Springwell Solar Farm

Written Summary of Oral Submissions
at Issue Specific Hearings 2, 3 and 4

EN010149/APP/8.22
Revision 1
Deadline 3
August 2025
Springwell Energyfarm Ltd

TITLE:
Plan 2a – Cumulative Solar Development and LCT
Central Plateau (Operational and Consented Projects
Only)

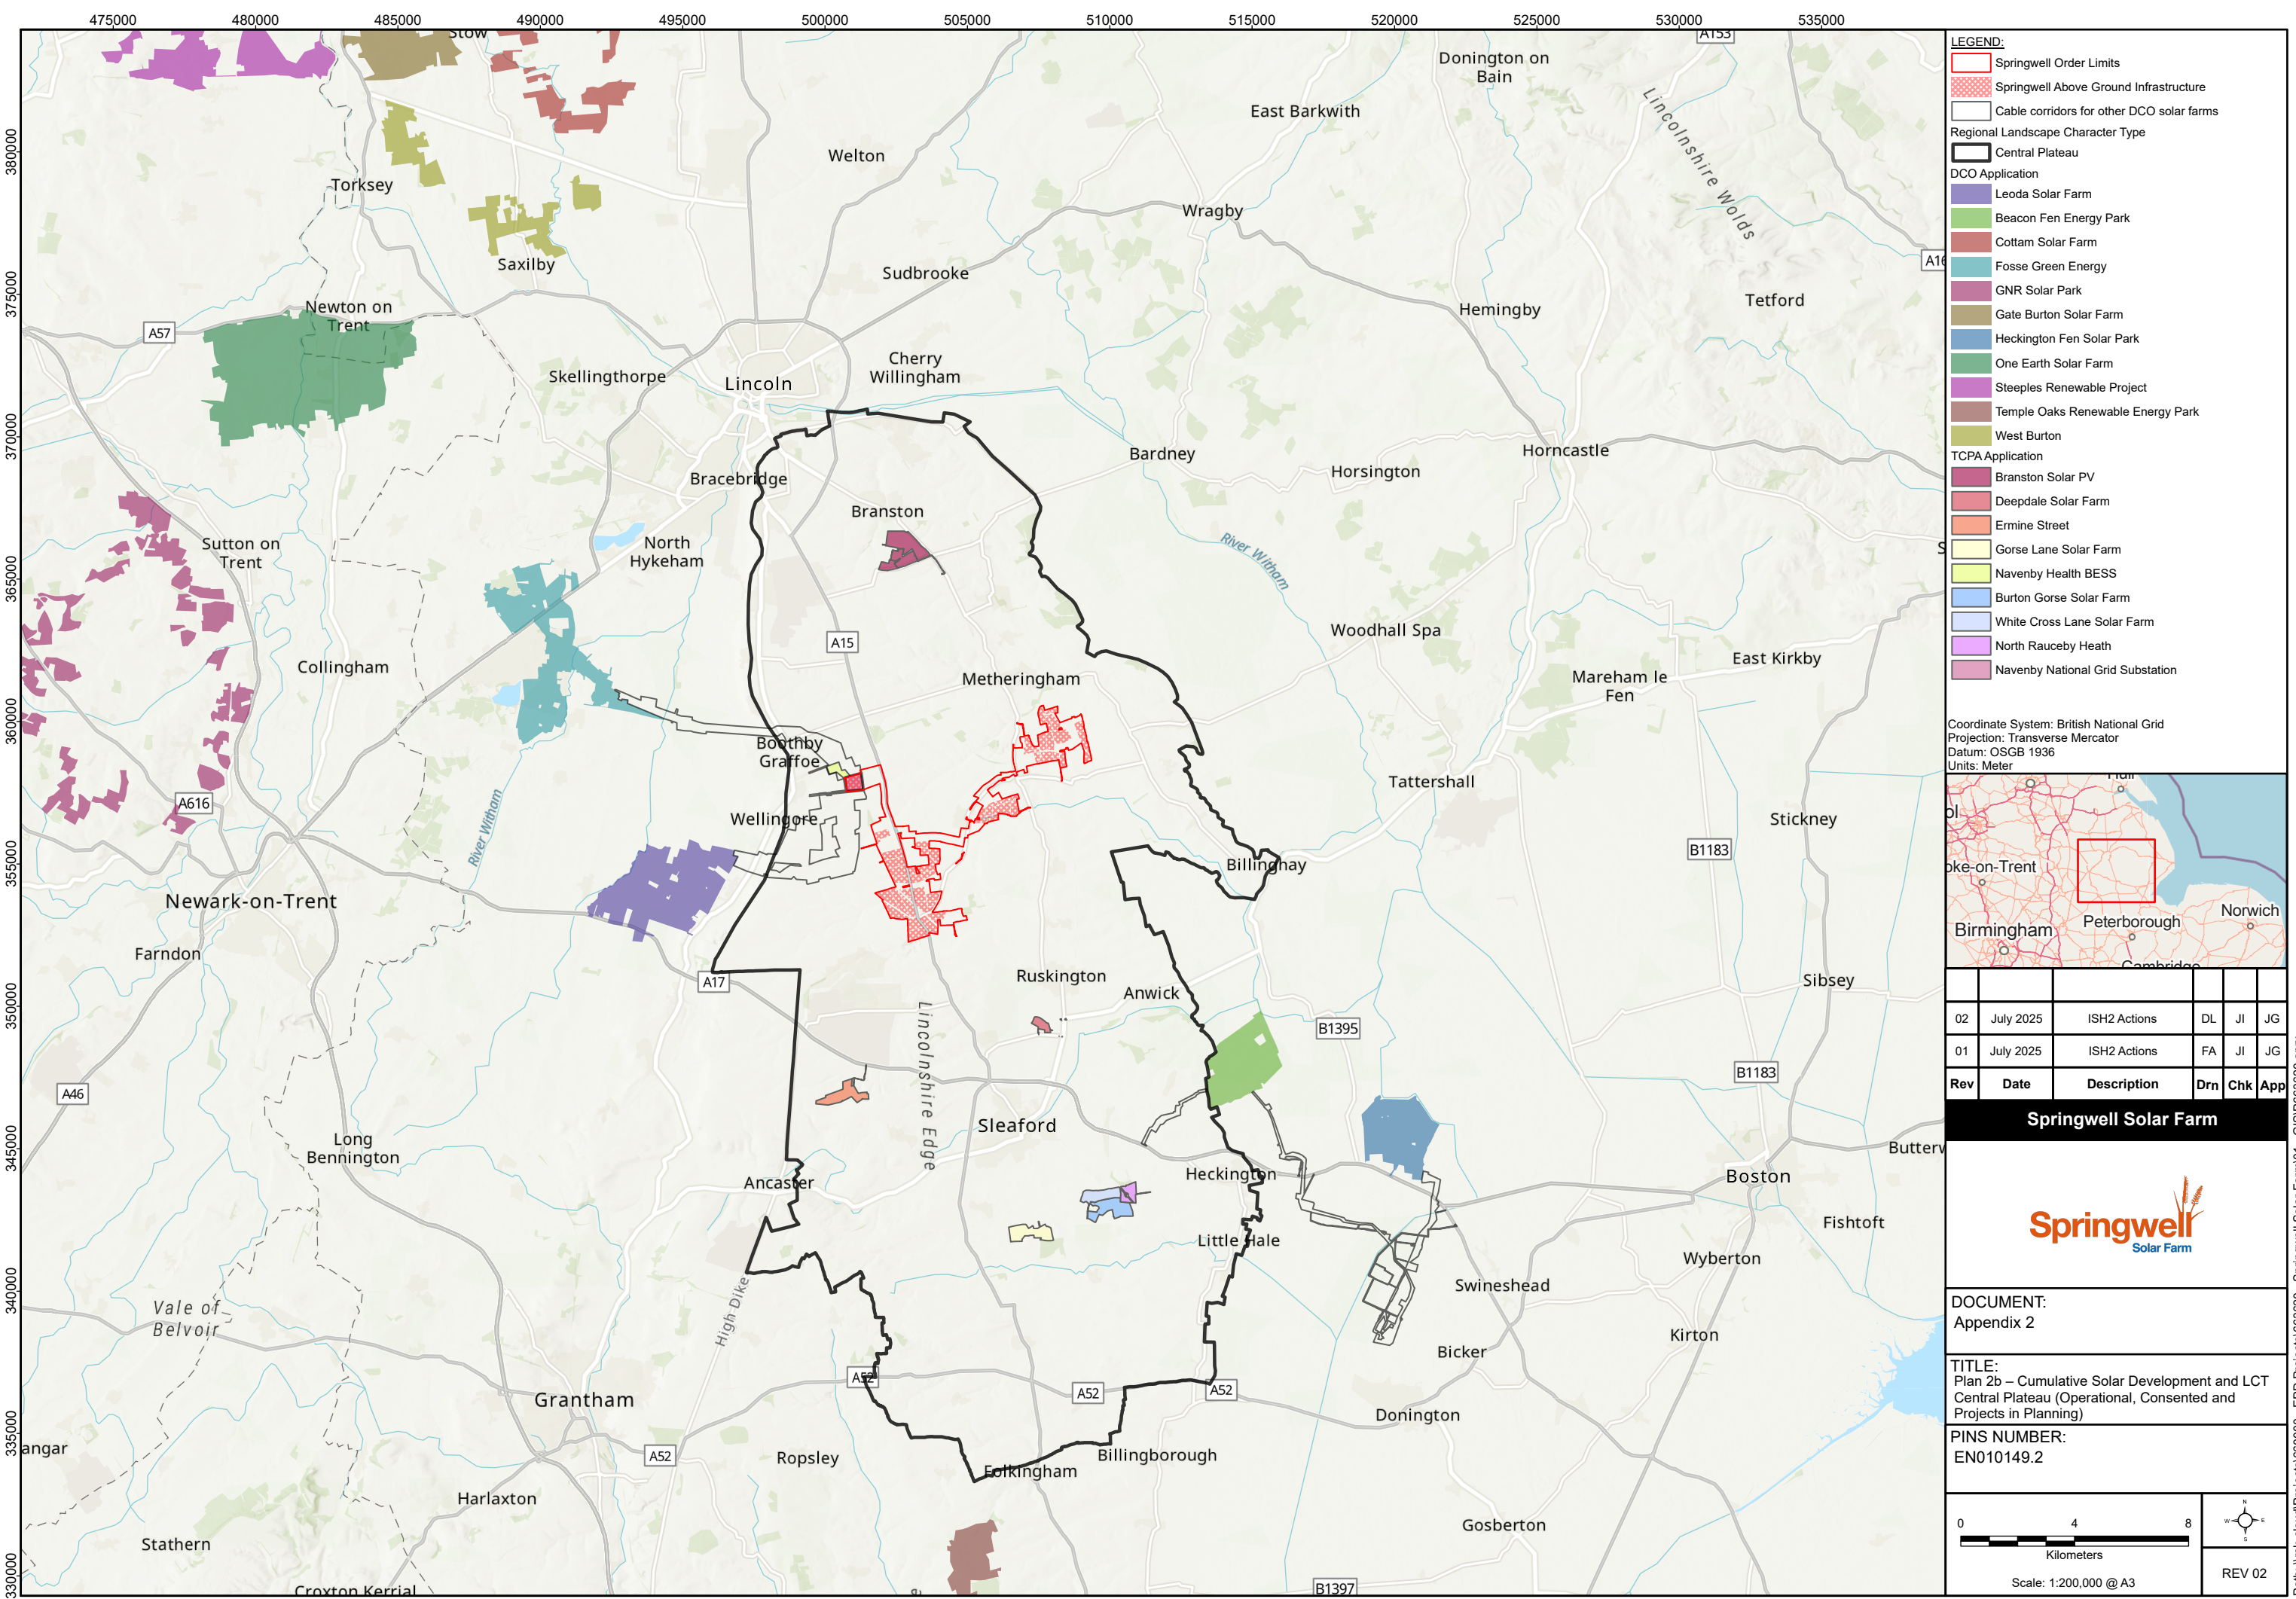
Action Point	Applicant's Response
Action Point 1: To provide overall % of area solar development and a revised Plan 3 of Appendix 2 of the Applicant's response to ExQ1 of all combined solar development within the landscape character areas Central Plateau LCT, LCA 7 and LCA 11. The Applicant should add on the map if the solar farms on the map show existing or proposed TCPA or NSIPs.	<p>The Applicant has updated Plans 1, 2 and 3 of Appendix 2 to the Response to First Written Questions (ExQ1) [EN010149/APP/8.14] [REP1-071], which have been appended to this document. In revising these plans it came to light that the Mareham Lane TCPA application (previously shown on Plans 1 and 2) was refused planning permission in March 2025. No appeal has been lodged against the refusal and therefore this site has been removed from all three plans for consistency. Conversely it has also been noted that a new TCPA solar farm application known as Burton Gorse Solar Farm was submitted on 26 March 2025. This has therefore been added to all three plans.</p> <p>In order to provide clarity on which projects are operational/consented and those which are in planning but not consented, two versions of each plan have been prepared. Plan 'a' in each case shows only those site (TCPA or NSIP) which are operational or consented. Plan 'b' in each case shows these sites plus others that are in planning but not yet consented.</p> <p>The updated figures are therefore:</p> <ul style="list-style-type: none"> Plan 1a – Cumulative Solar Development and NCA 47 (Operational and Consented Projects Only) Plan 1b – Cumulative Solar Development and NCA 47 (Operational, Consented and Projects in Planning)

Action Point	Applicant's Response												
	<ul style="list-style-type: none"> Plan 2a – Cumulative Solar Development and LCT Central Plateau (Operational and Consented Projects Only) Plan 2b – Cumulative Solar Development and LCT Central Plateau (Operational, Consented and Projects in Planning) Plan 3a – Cumulative Solar Development LCAs (Operational and Consented Projects Only) Plan 3b – Cumulative Solar Development and LCAs (Operational, Consented and Projects in Planning) <p>The table below summarises the total % of land area in the relevant NCA/LCT/LCAs that would be occupied by above ground solar infrastructure taking account of the Springwell Solar Farm, National Grid Navenby Substation and other TCPA/NSIP solar projects. The figures are broken down further into the % area occupied by operational or consented projects and those in planning.</p>
